CITY OF ALBUQUERQUE

RE: **Lot 21-A Block 2 Unit 18, S.A.D. 228**
7704 Compass Dr. NW
Grading and Drainage Plan
Engineers Stamp Date 1-10-20 (D10D003G21A)

Based upon the information provided in your submittal received 1/9/20, this plan cannot be approved for Grading Permit until the following comments are addressed

RAMOS, MANUEL (M. SANCHEZ) - GRADING & DRAINAGE PLAN

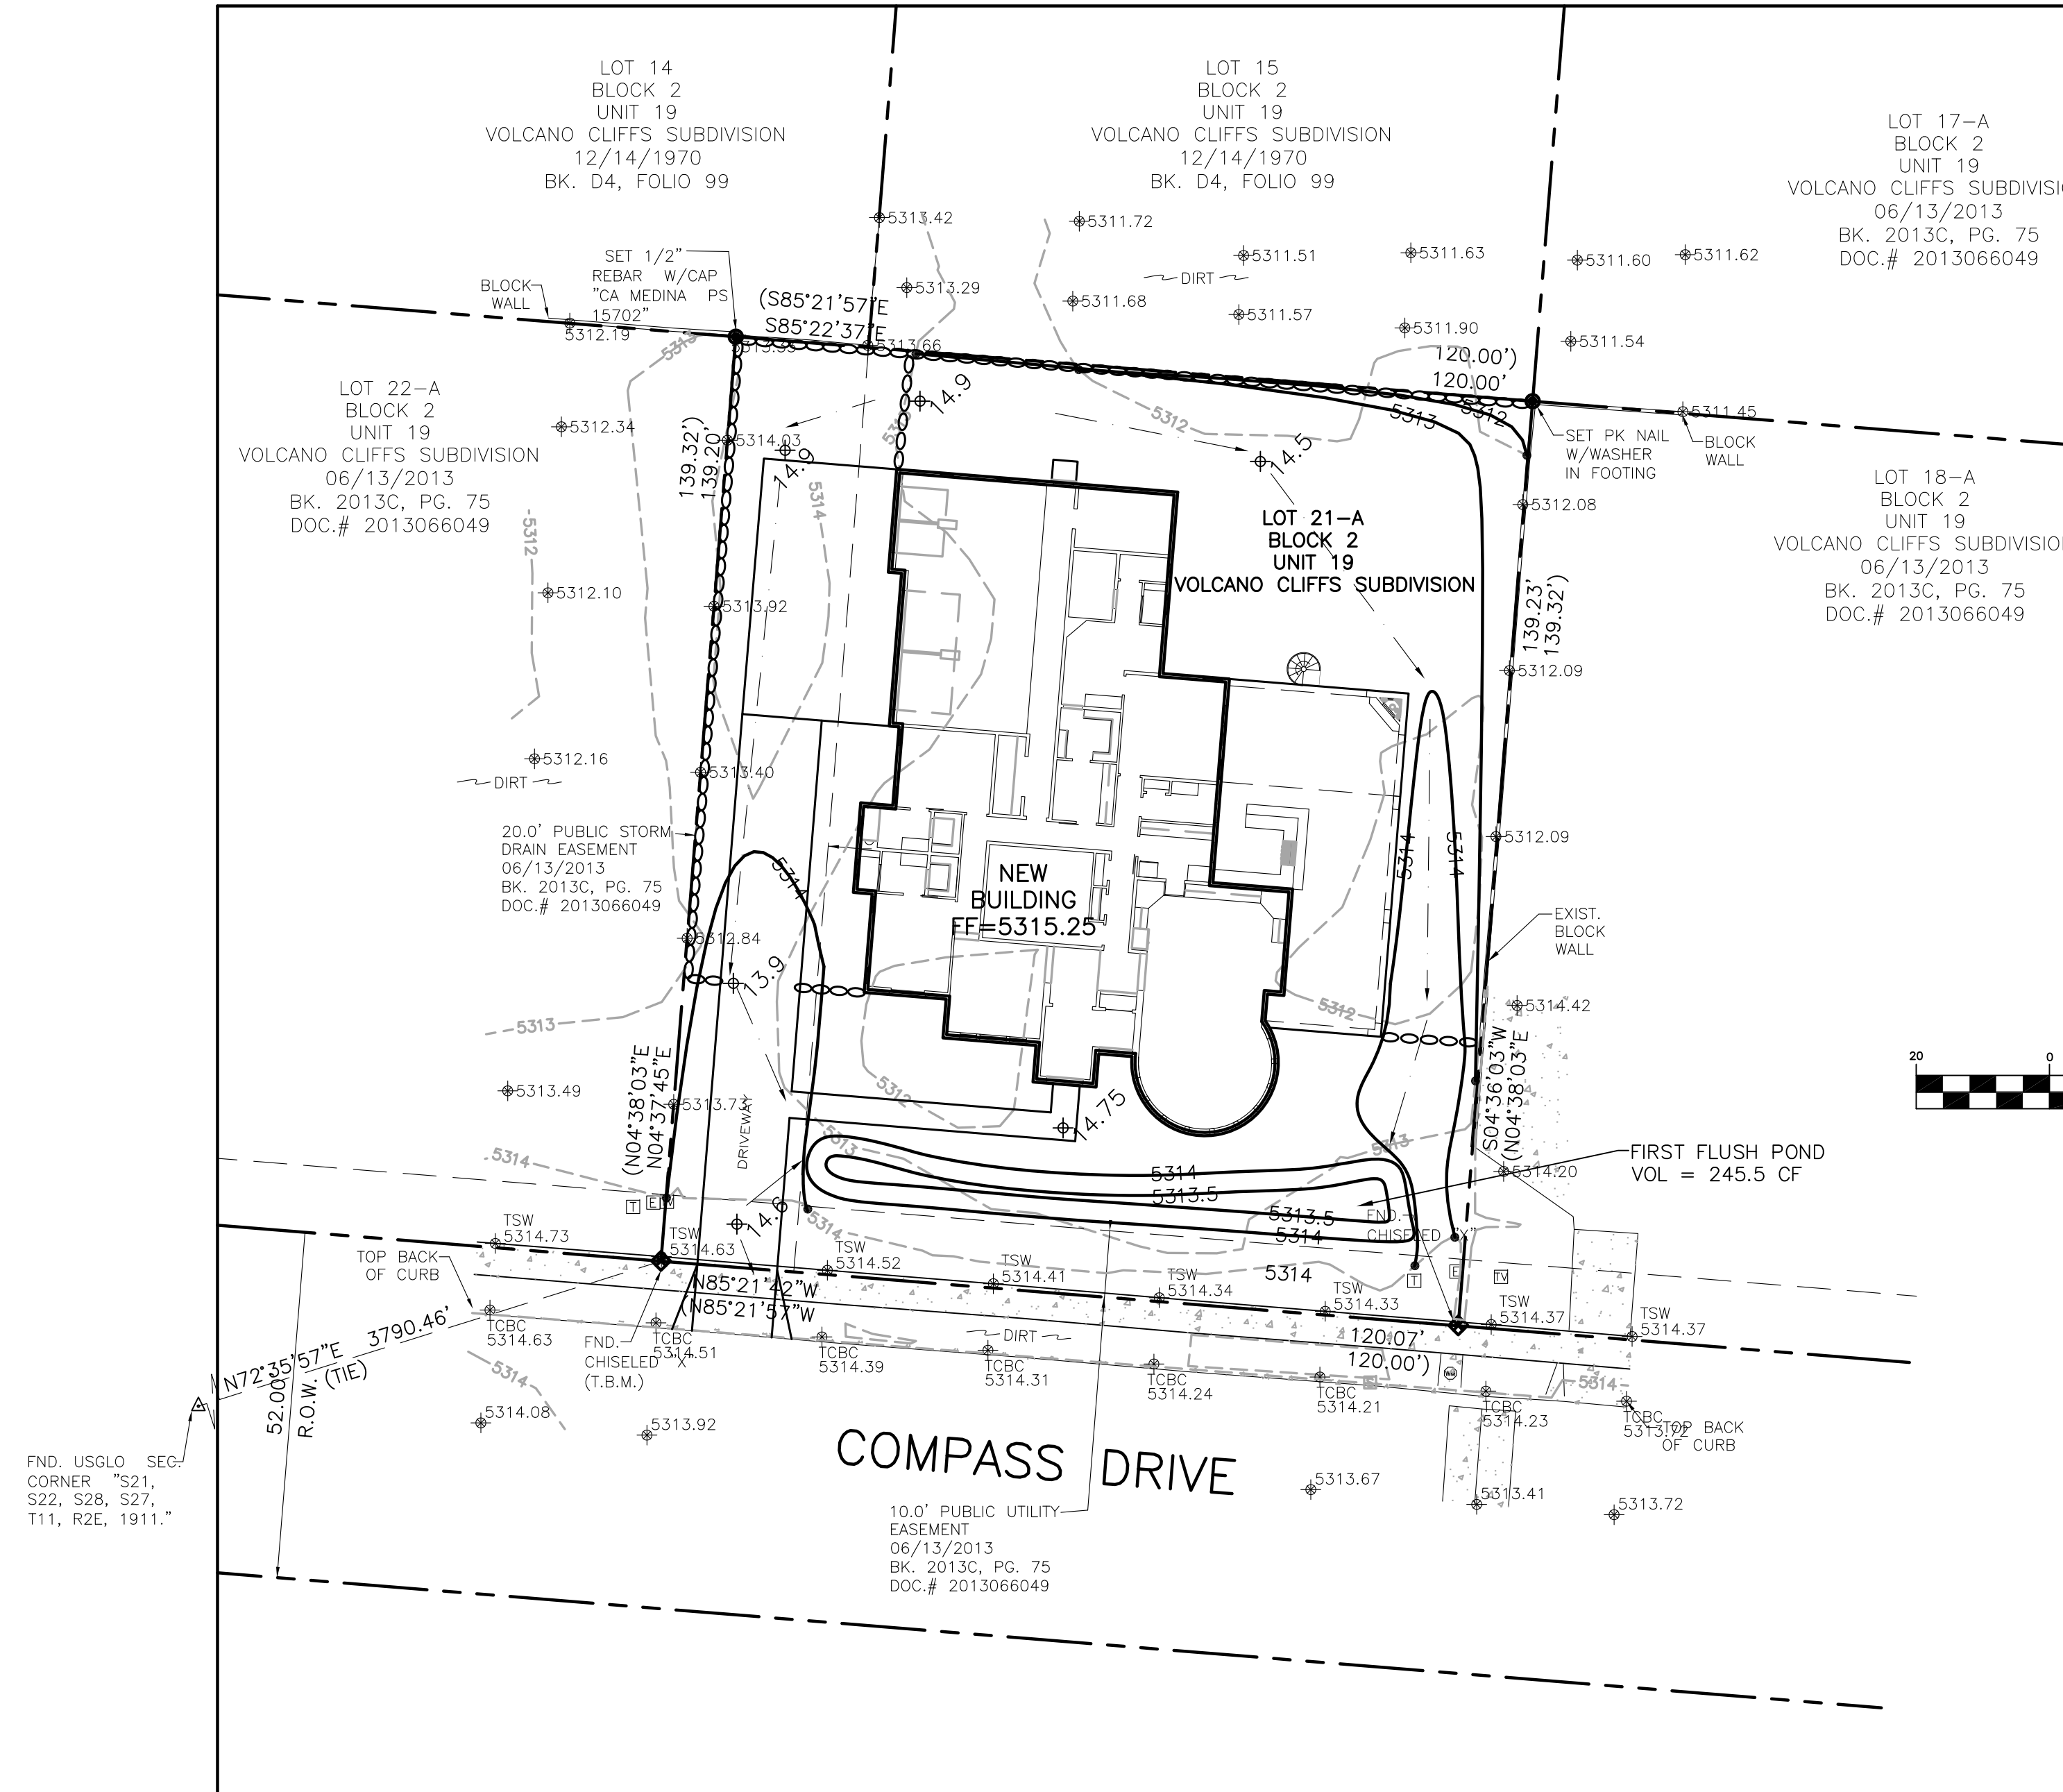
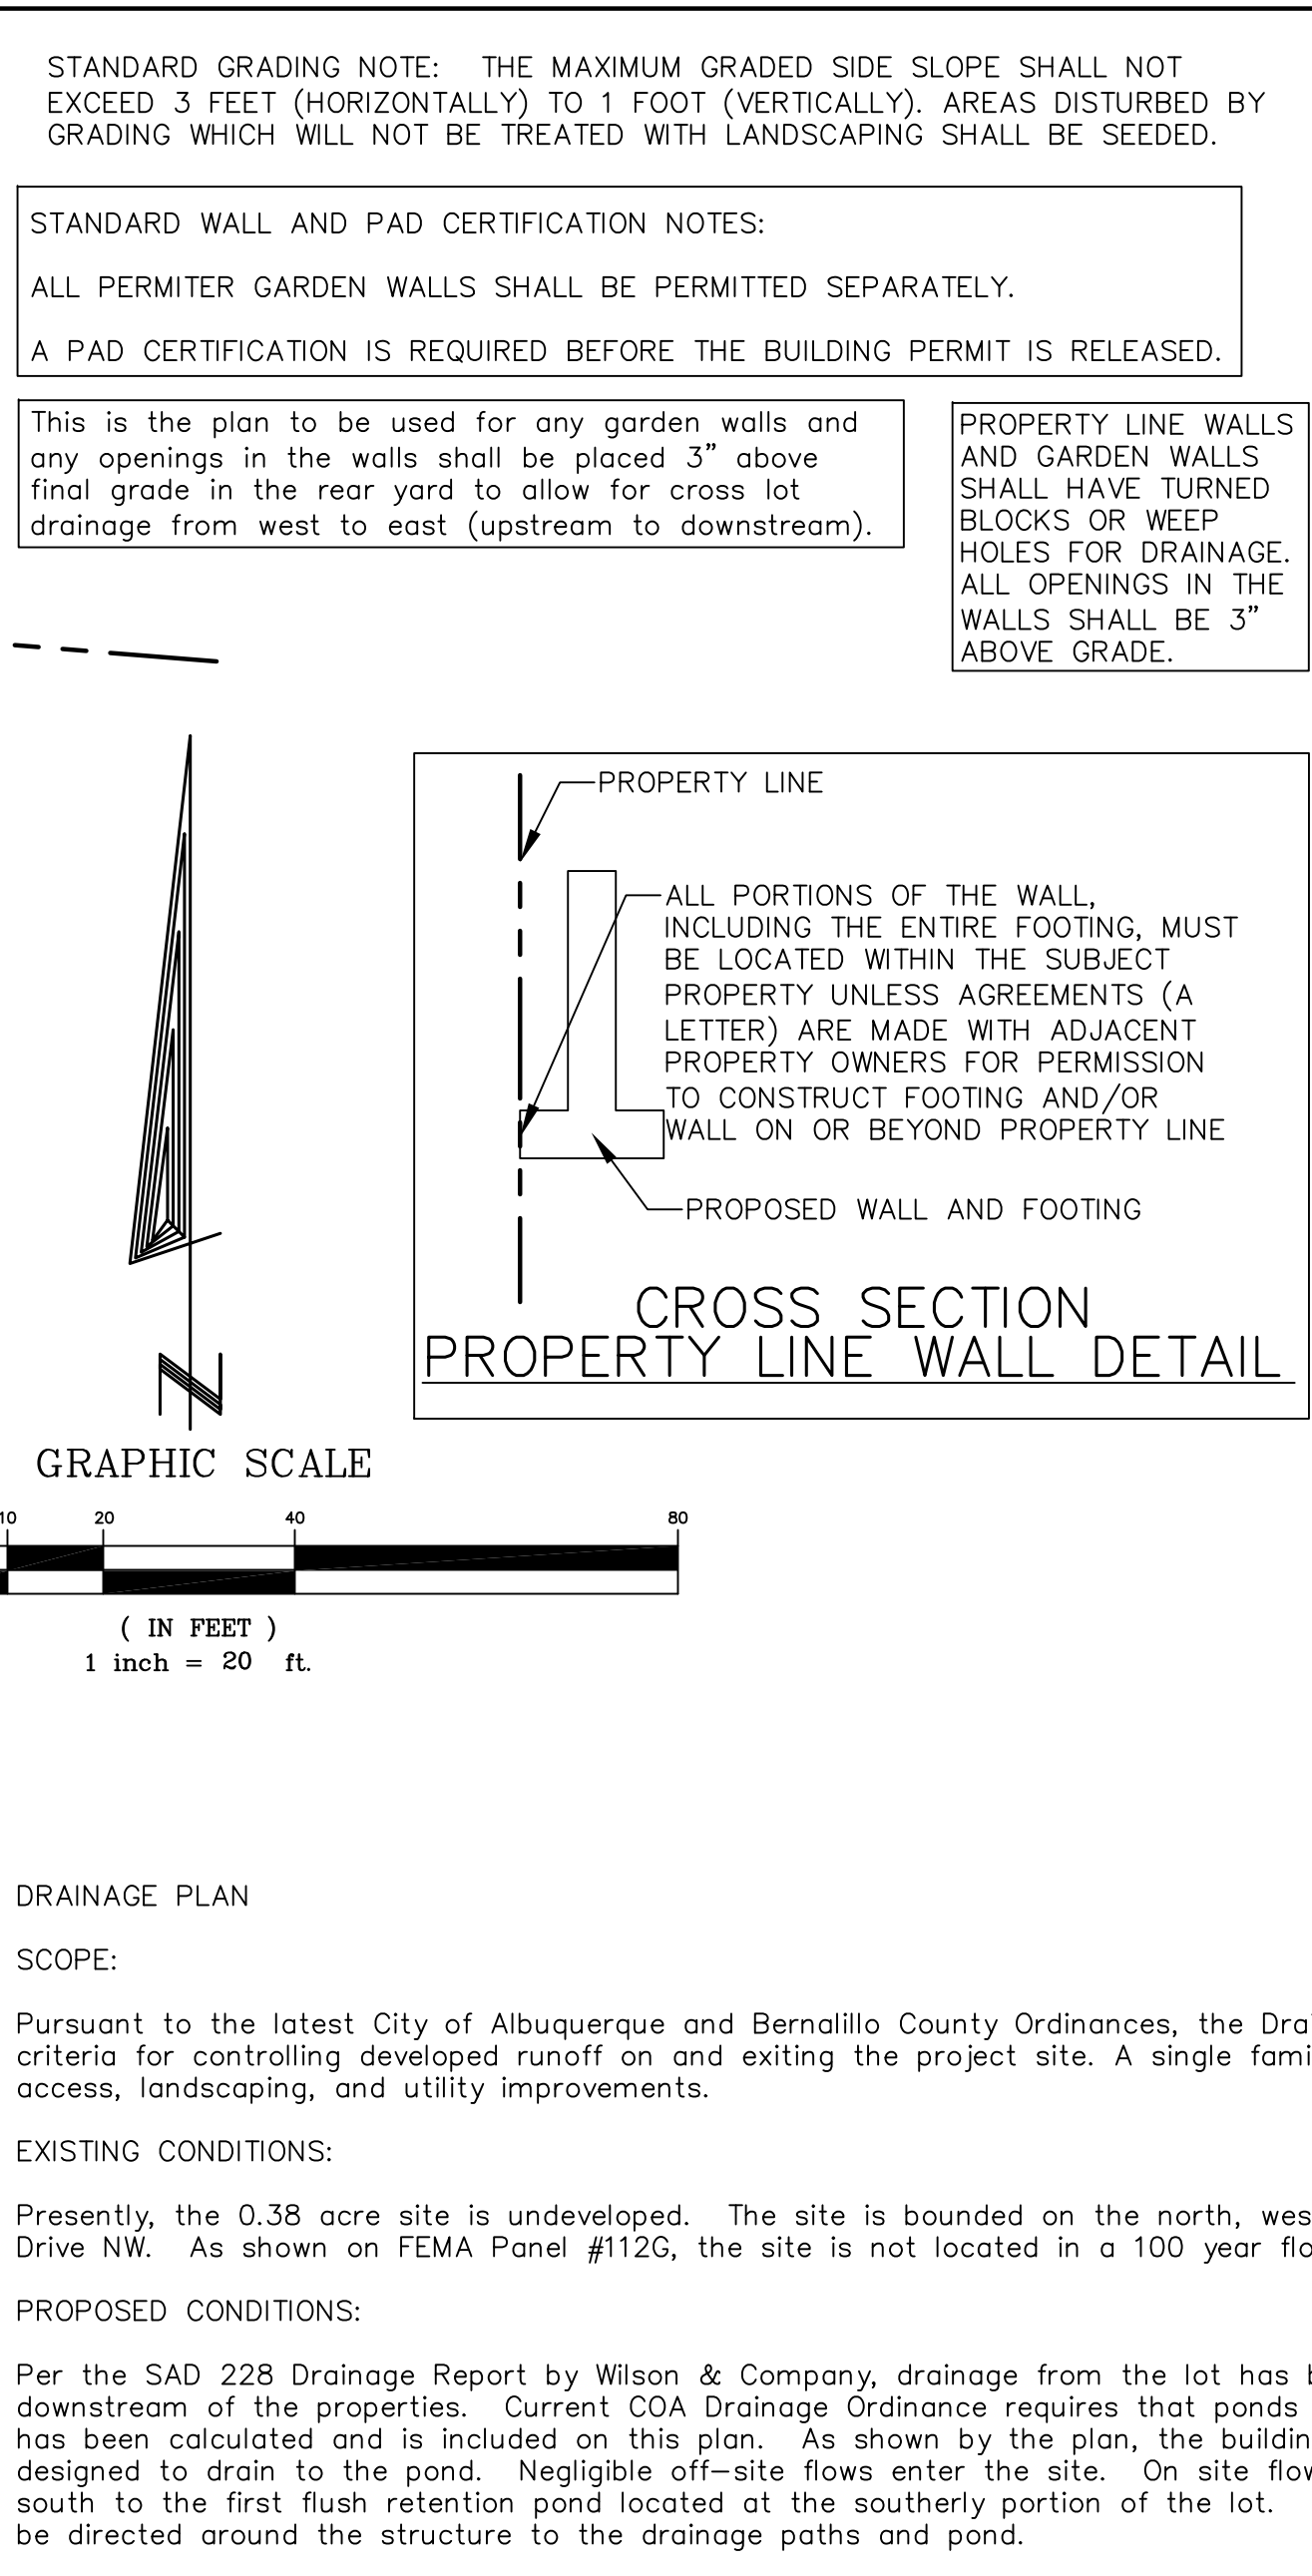
- Show the 24" Storm Sewer pipe in the west property line.
- Provide a statement that if a wall is built above the 24" SS line and if repairs should need to take place the wall will be removed and not replaced. Replacement will be at the cost of the owners.
